TUNITAS CREEK BEACH IMPROVEMENTS PROJECT

**COUNTY PROJECT NO. P30T1
PROJECT FILE NO. E4995**

ADDENDUM NO. 1

The following **Addendum No. 1** to the above referenced project, dated April 21, 2023, shall be included in the project specifications and plans.

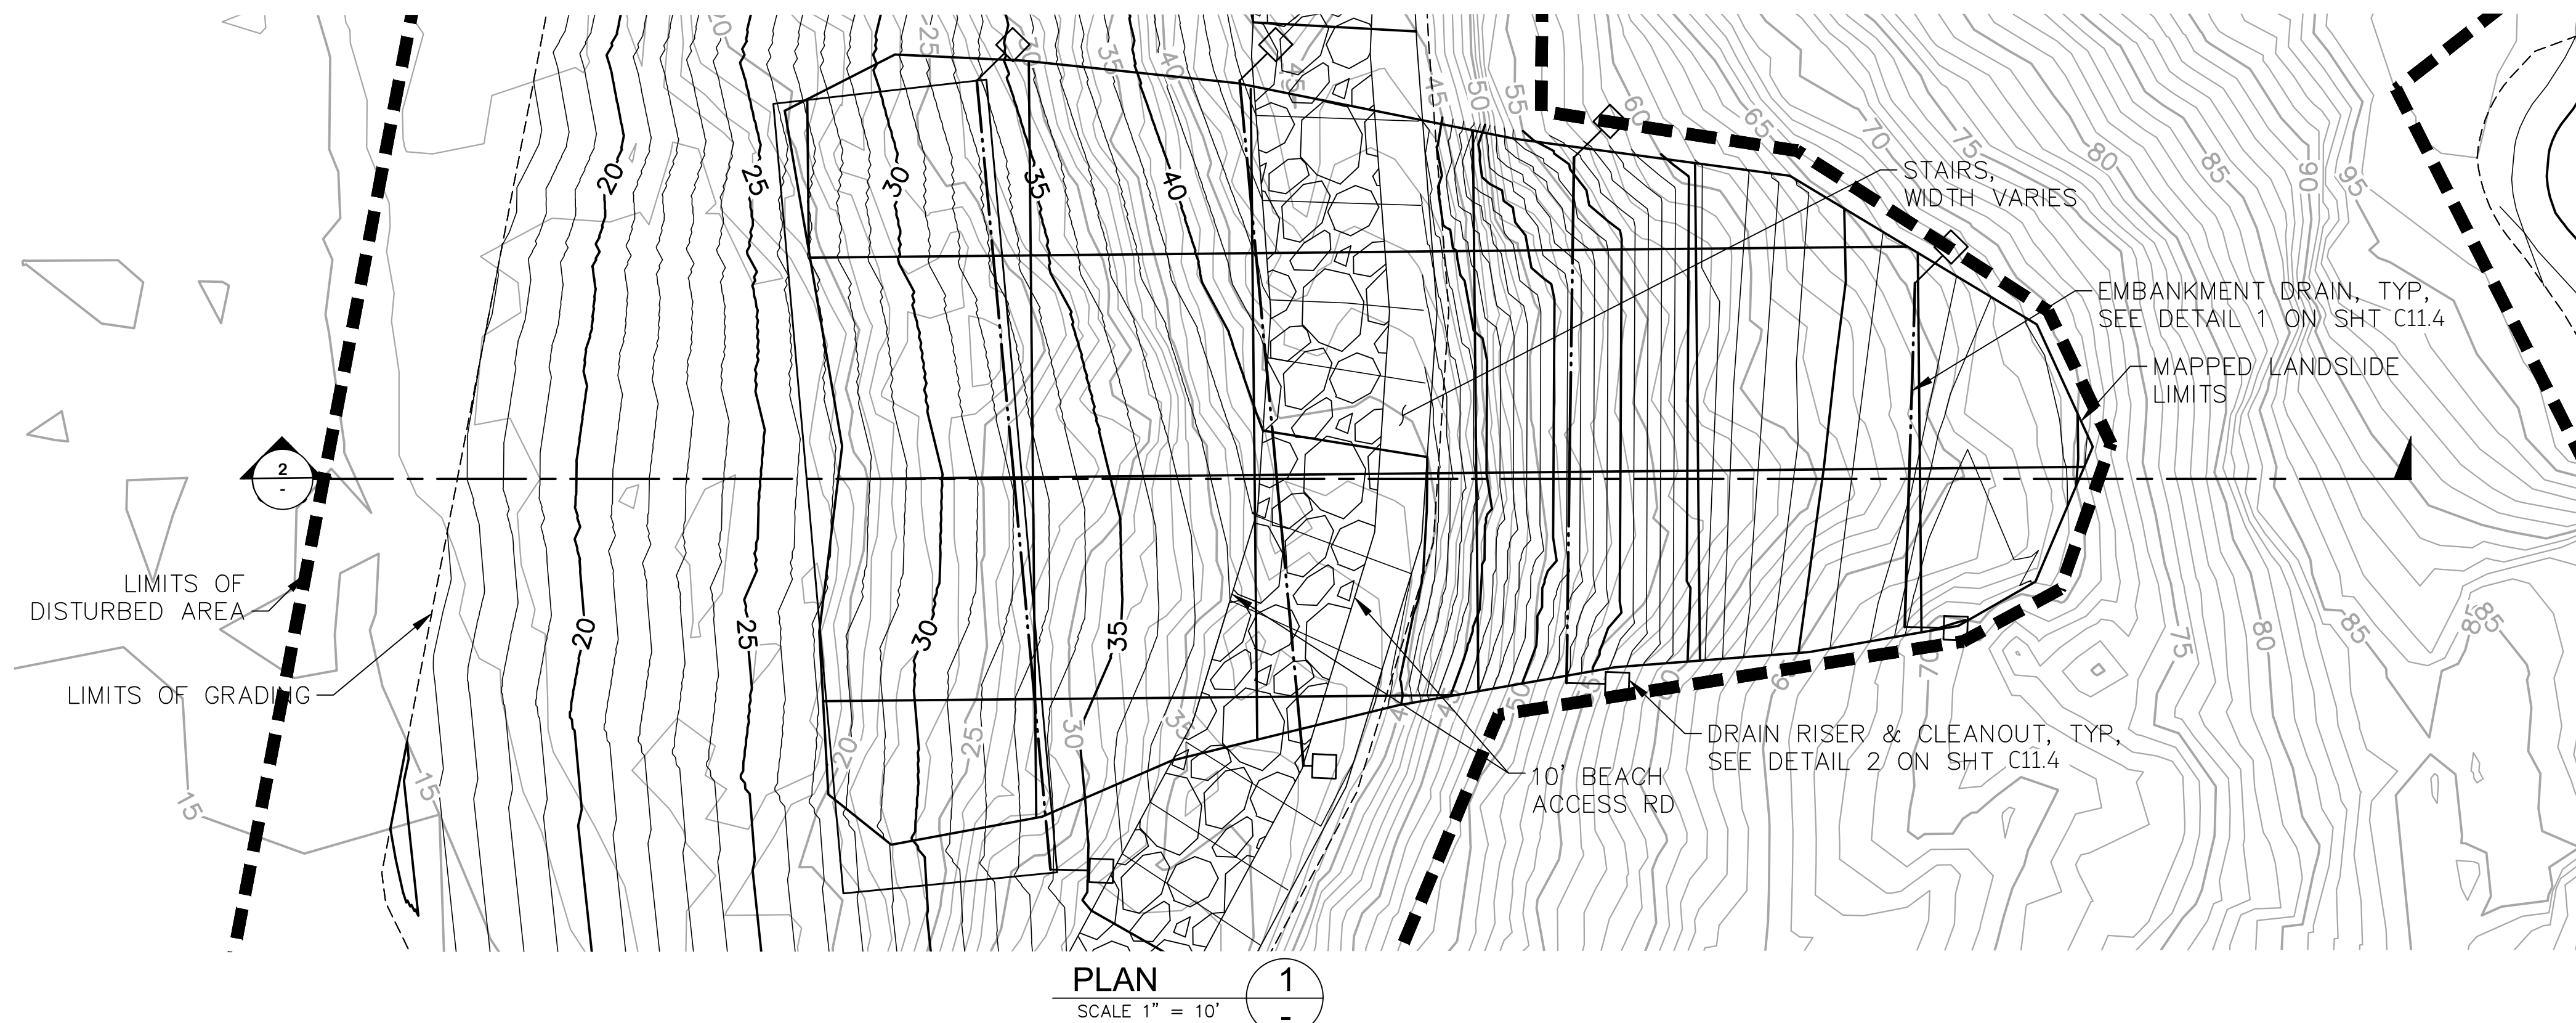
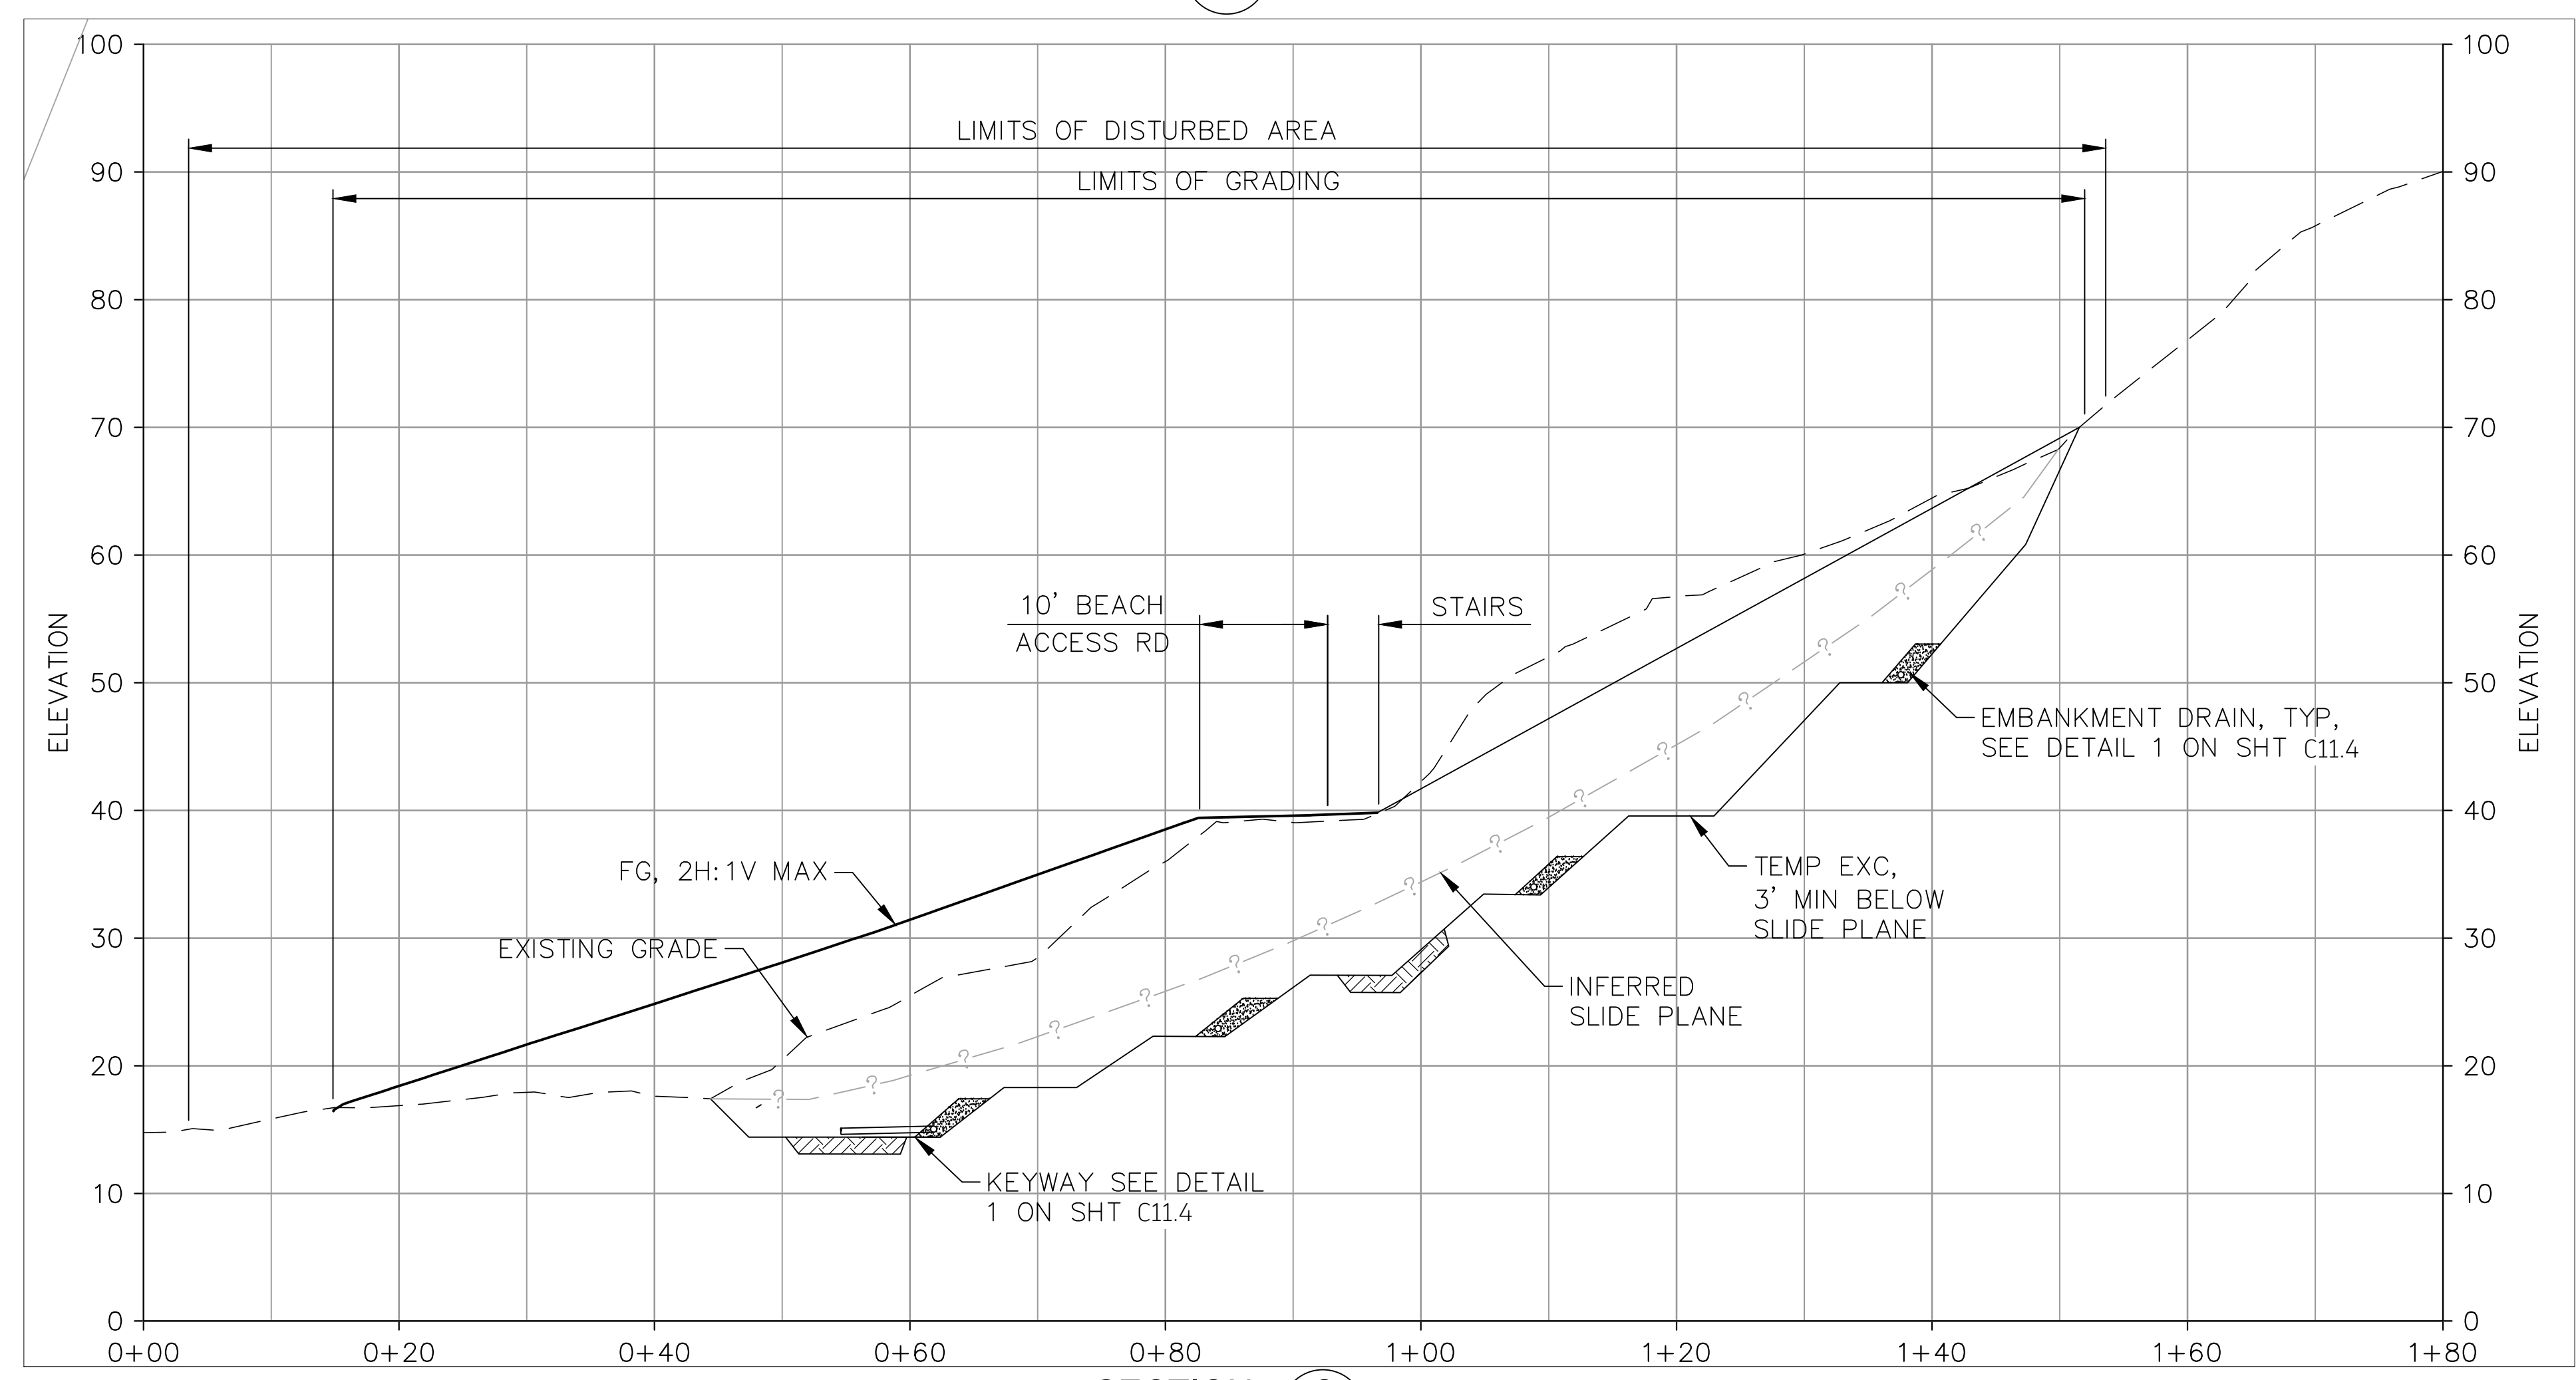
12. Note 3 of Plan Sheet C-11.1 through C-11.3 has been updated. Sheet C-11.1, Sheet C-11.2, and Sheet C11.3 shall be replaced in the Project Plans:

Replace Plan Sheet C-11.2 (Sheet 41 of 124) with Sheet C-11.2 (rev) (Sheet 41 of 124).

- NOTES:
- EXCAVATION CONFIGURATION SHOWN IS PRELIMINARY. FINAL CONFIGURATION SHALL KEY ENGINEERED FILL 3 FEET INTO COMPETENT BEDROCK. THE DEPTH TO COMPETENT BEDROCK SHALL BE DETERMINED DURING CONSTRUCTION BY THE PROJECT GEOTECHNICAL ENGINEER OR GEOLOGIST.
 - FACE OF KEYWAY TO BE EMBEDDED 3 FEET MINIMUM INTO COMPETENT BEDROCK ON THE DOWNHILL SIDE AS DETERMINED BY THE PROJECT GEOTECHNICAL ENGINEER OR GEOLOGIST.
 - SEEPAGE ZONES ENCOUNTERED DURING EXCAVATION FOR THE LANDSLIDE MITIGATION SHALL BE EXCAVATED IN CONFORMANCE WITH NOTE 1 AND A SUBDRAIN INSTALLED AS OUTLINED ON DETAIL 1 ON SHEET C11.4 "EMBANKMENT DRAIN." ALL IDENTIFIED SEEPAGE ZONES SHALL RECEIVE 100 PERCENT COVERAGE OF A 2 FOOT THICK LAYER OF CALTRANS CLASS 2 PERMEABLE MATERIAL. THE PERFORATED SUBDRAIN PIPE SHALL BE CONNECTED TO THE SUBDRAIN OUTFALL SYSTEM.
